CLOVE RIVER DAM

NJ 00035

6 PHASE 1 INSPECTION REPORT  
NATIONAL DAM SAFETY PROGRAM

Clove River Dam (NJ-00035). Hudson River  
Basin, Clove Brook, Sussex County,  
New Jersey. Phase 1 Inspection report.

PLATE 3

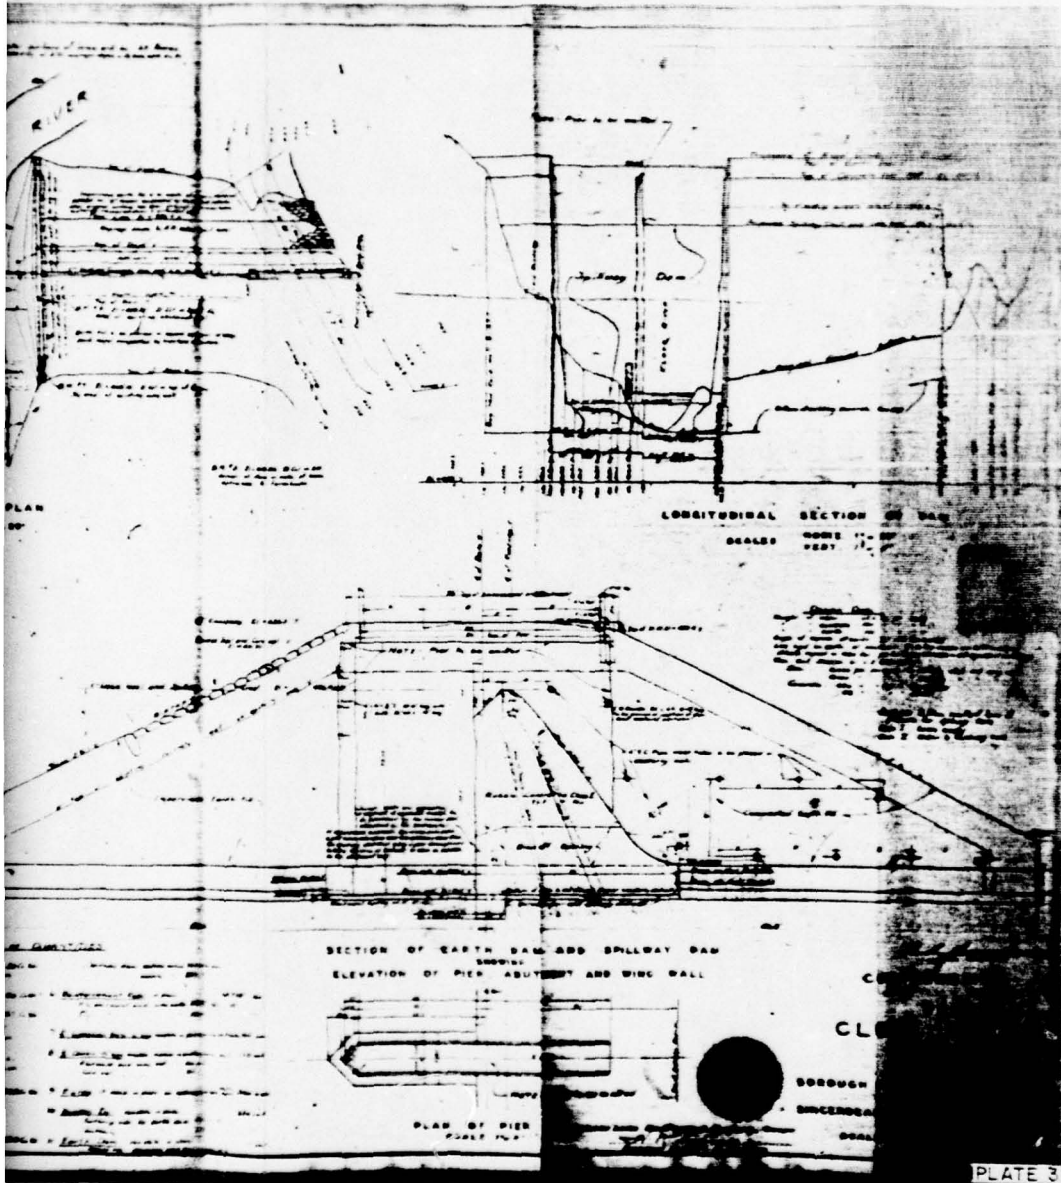
The existing dam drawing should be annotated and updated to form a coherent as-built set within 3 months.
